Addendum 1

In Reference to: The Wetland Baseline Findings linked to a Preliminary Conceptual Enhancement Report (dated: June, 2010); northern 106 Acres associated with the McKenzie Conservation Area (Spokane County, Washington).

Wetland Baseline Findings linked to a Preliminary Conceptual Enhancement Report

Northern 106 Acres associated with the McKenzie Conservation Area
(Spokane County, Washington)

Figure 8 Newman Lake Pool Elevation

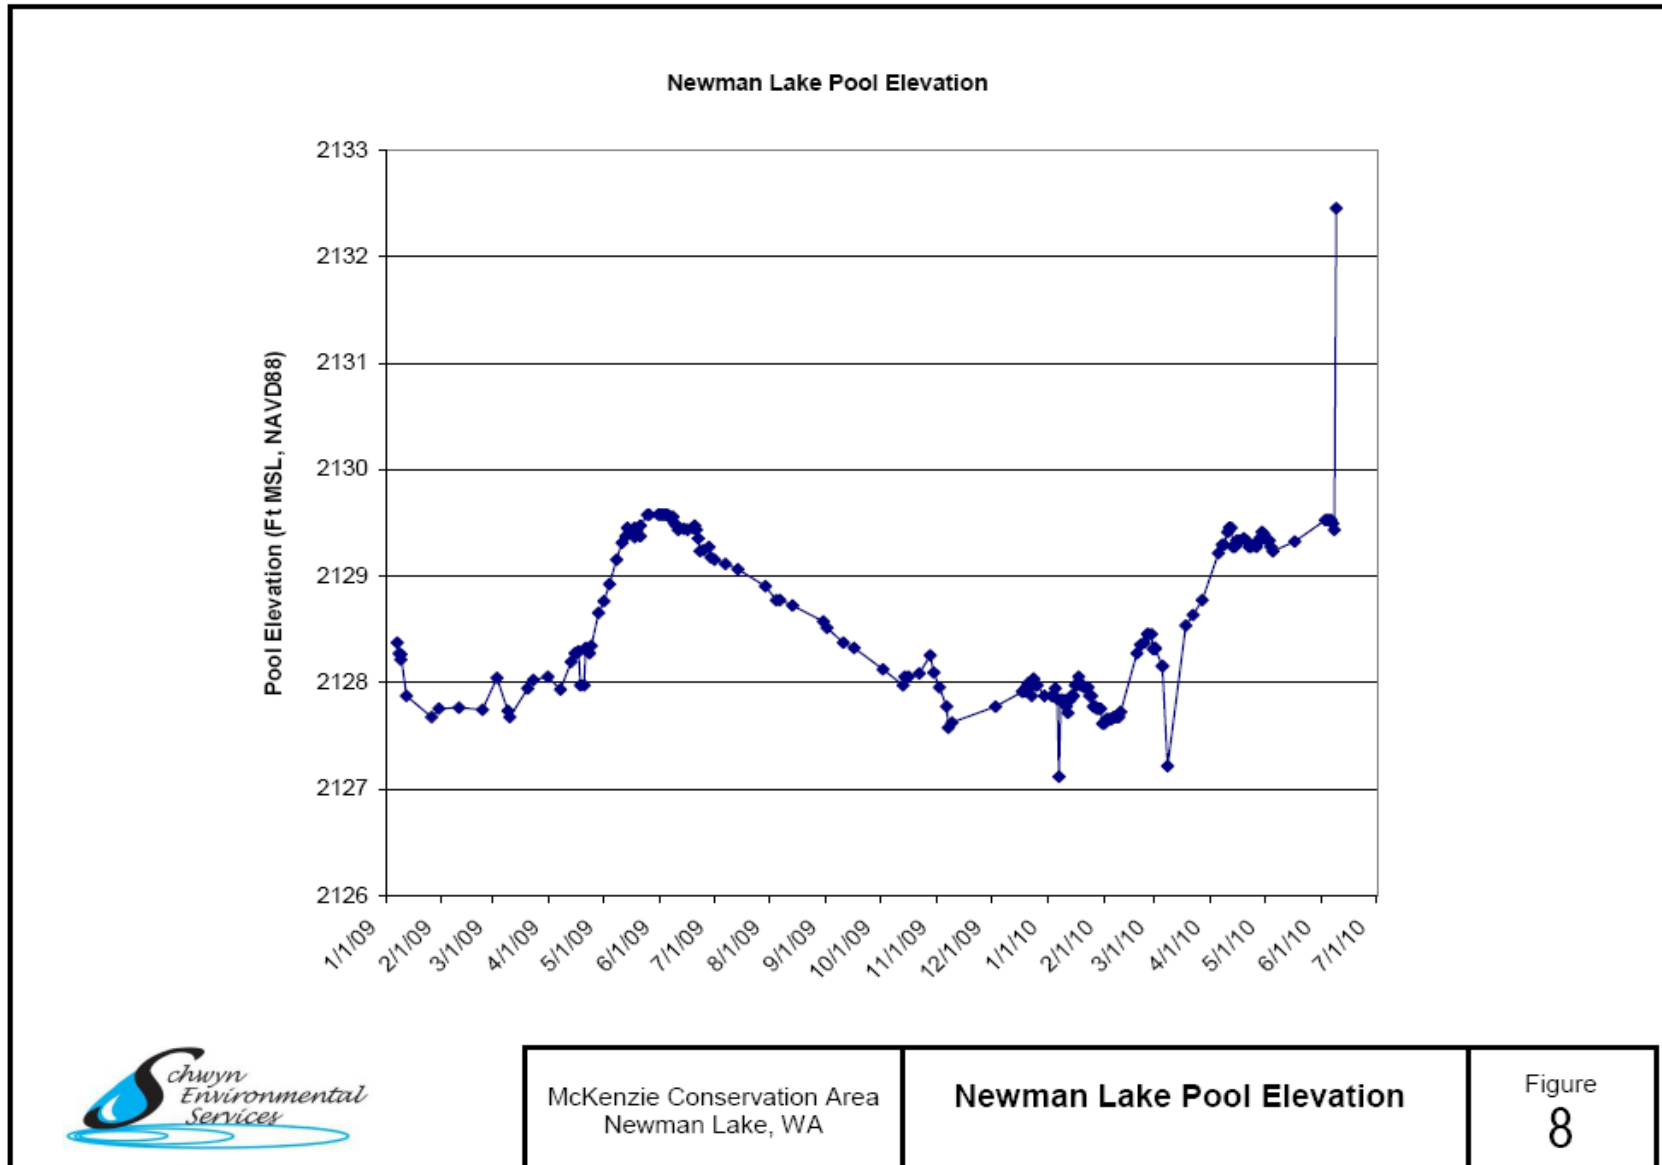
Within Appendix C, specifically the table illustrating the Newman Lake Pool Elevations, the elevation presented on June 9, 2010 (page 4 of 4), should have been 2,129.455 Ft MSL (NAVD88). This change is significant, since it is a three foot difference in relation to what had been presented.

- (1) On page 11, within the second paragraph, the last sentence should be omitted. The sentence that should be deleted reads, "However, on June 10, 2010, during atypical conditions, the pool rose to 2,132.45 feet which could impact surface and groundwater conditions on the site."
- (2) On page 12, Figure 8, the elevation for the final data point, June 9, 2010 is corrected to 2,129.455 Ft MSL, NAVD88. Consequently, Figure 8 should not display a noticeable (3-foot) increase in lake pool elevation correlated to the far right hand side of the line-graph.
